2 ARCHITECTURAL ADDENDUM

3 MECHANICAL ADDENDUM

**The following changes/clarifications in the tender documents are effective immediately.
This addendum will form part of the contract documents.**

PACIFIC AGRI-FOOD
RESEARCH CENTRE
MECH & ELEC RETROFIT

CHEMICAL STORAGE
BUILDING

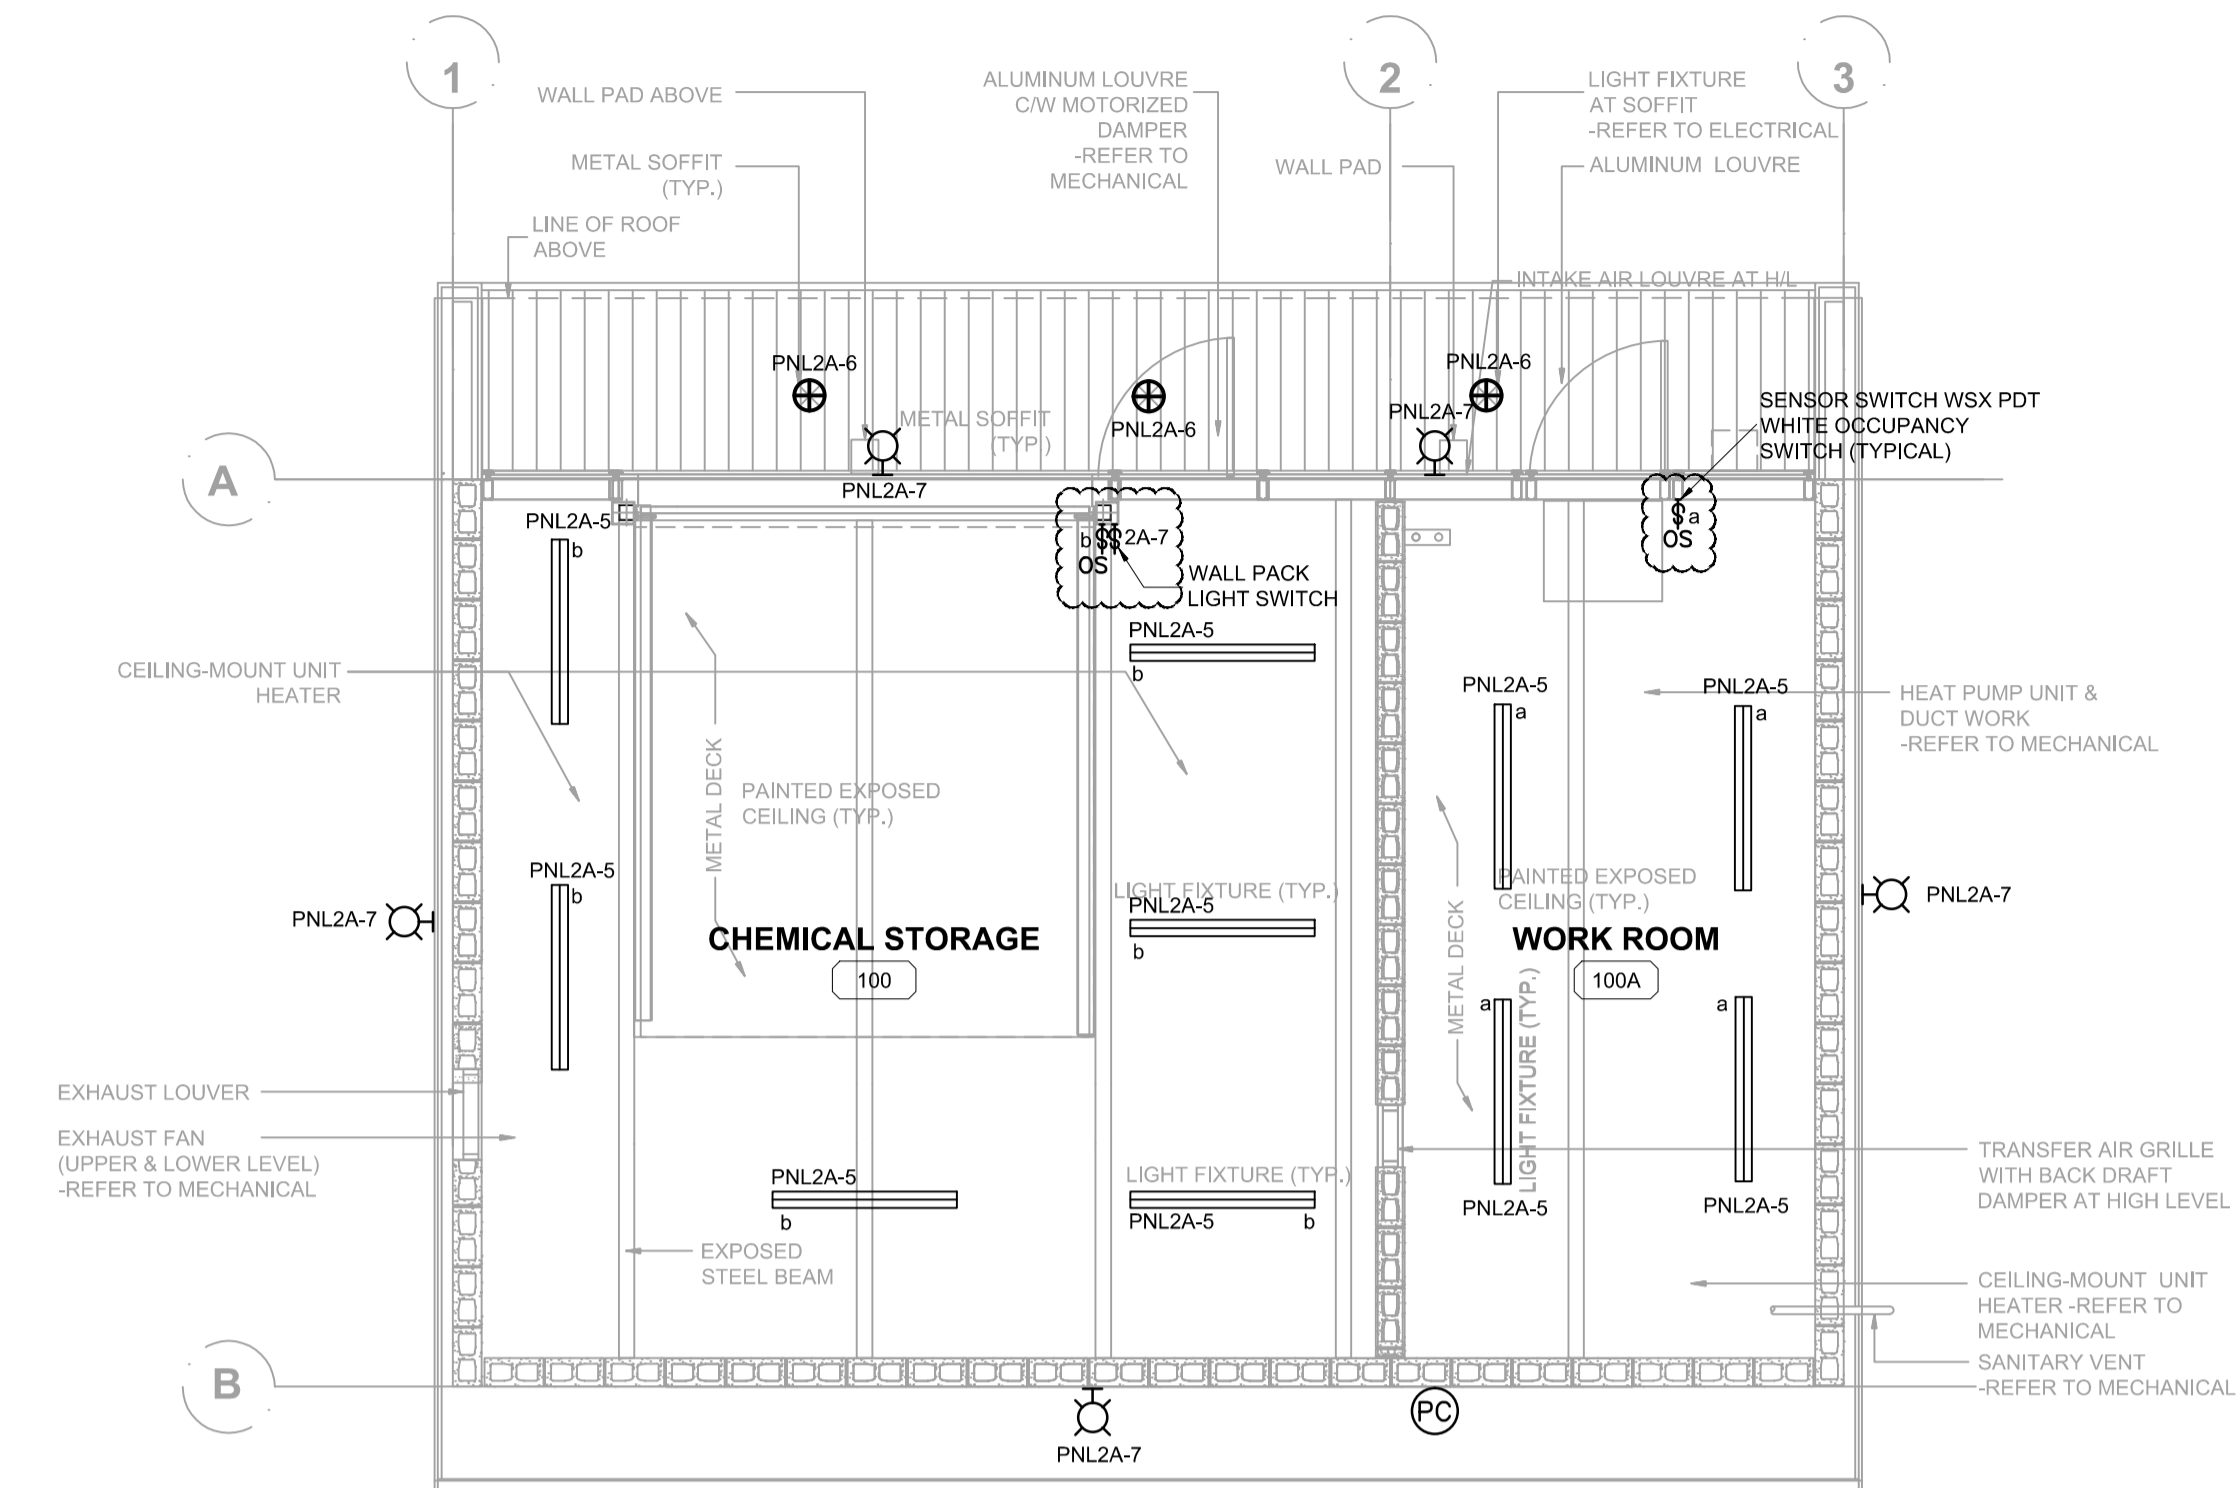
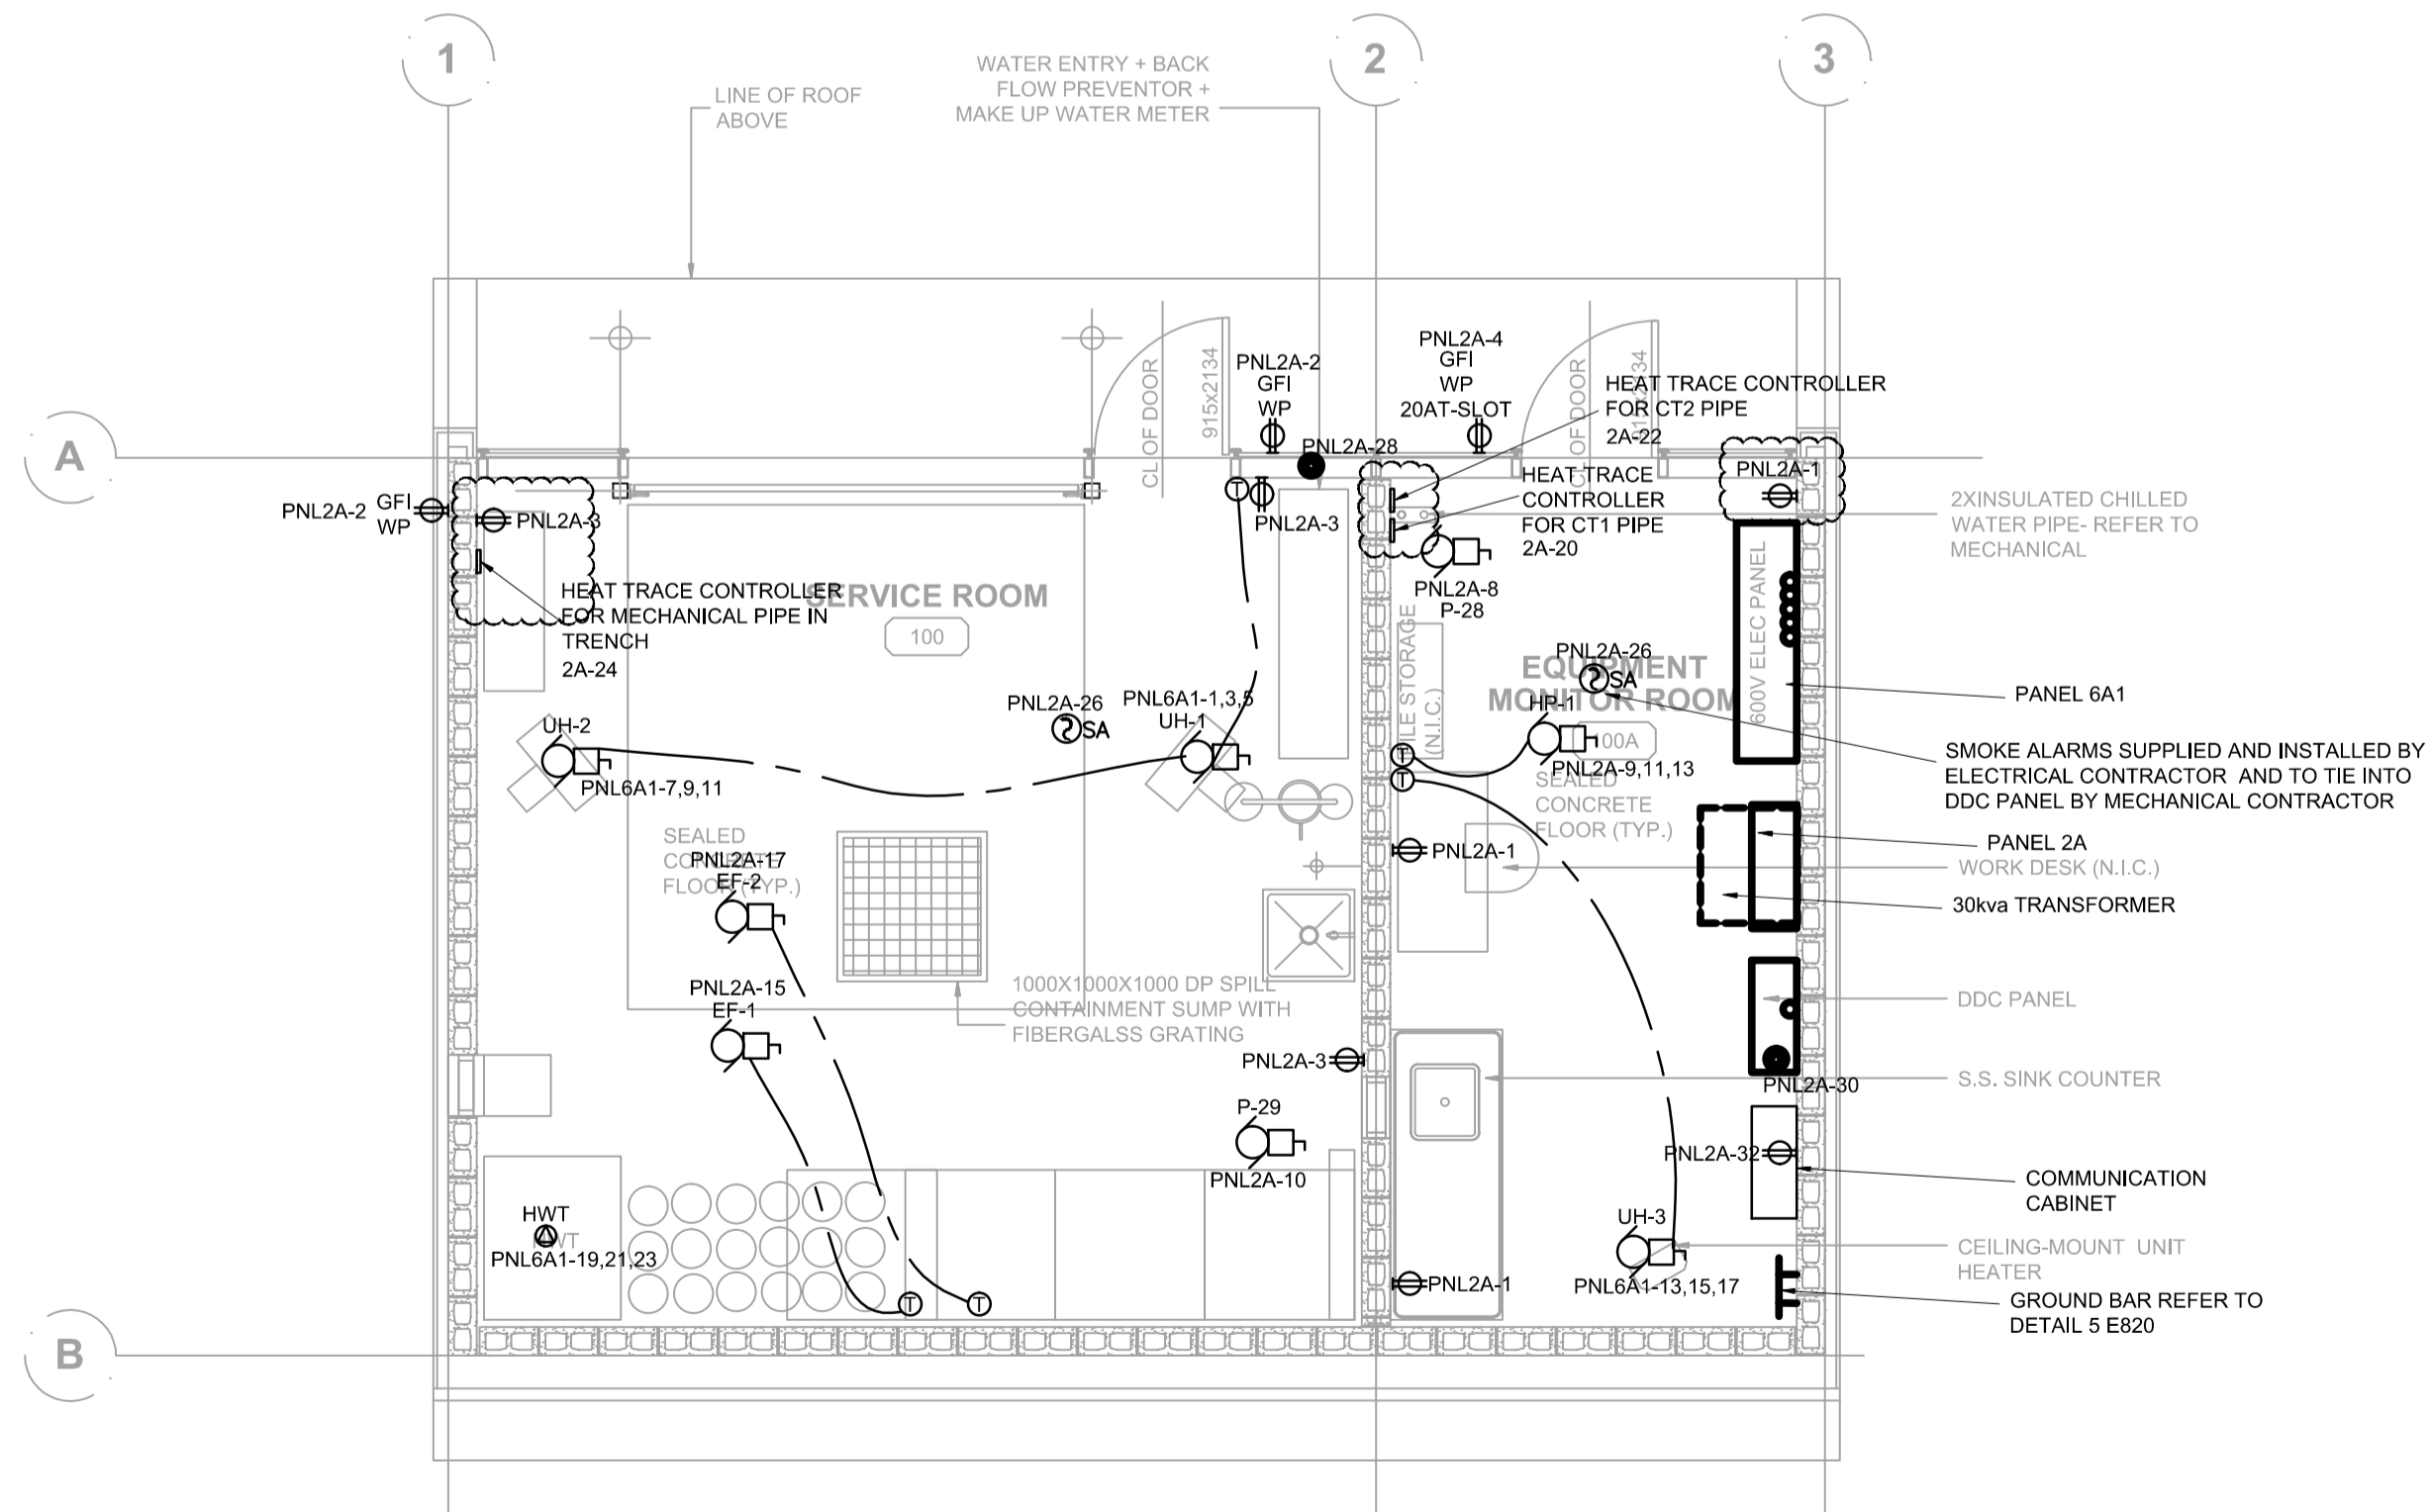
- .1 Move light switches near GL A/2 to HSS post.
 - .2 Move light switch near GL A/3 closer to door.
 - .3 Move receptacle and heat trace controller for mechanical pipe in trench near GL A/1 to masonry wall.

- .4 Move heat trace controllers for CT2 pipe and CT1 pipe near GL A/2 to masonry wall.
 - .5 Move receptacle near GL A/3 to masonry wall.
 - .6 Add drawing scales and scale bar.
